PCN – Process Change Notification

Change:	TG.30.8113
Date:	2016/12/16
Author	Haley Tsai

Model#	Part Number	Changes
Apex 2G/3G/4G Terminal Antenna for Cellular modules with Assisted GPS 90° Hinged R/A SMA(M)	TG.30.8113	Amend Connector Dimensions.
		Amend Housing Dimensions.
		Amend Hinge Top & Bottom Material

Illustration of Change

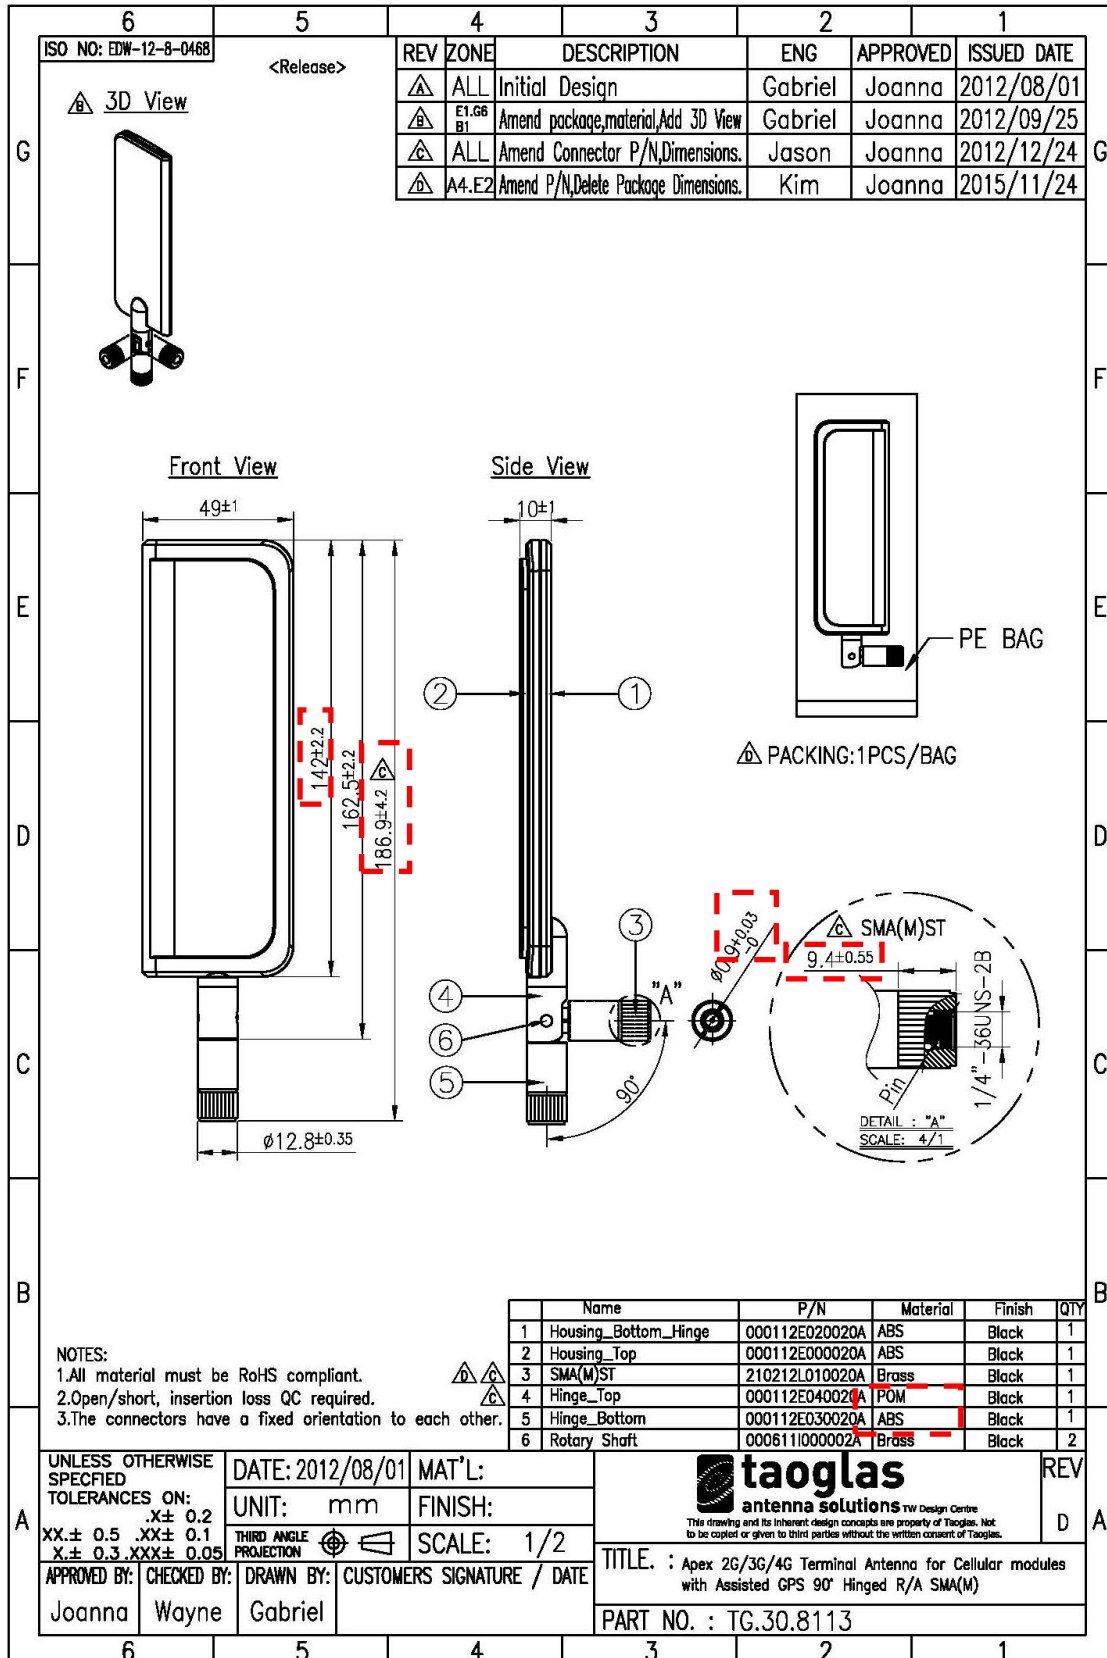
1. Amend connector dimensions and tolerances.
2. Amend housing dimensions and tolerances.
3. Amend hinge Top & bottom material
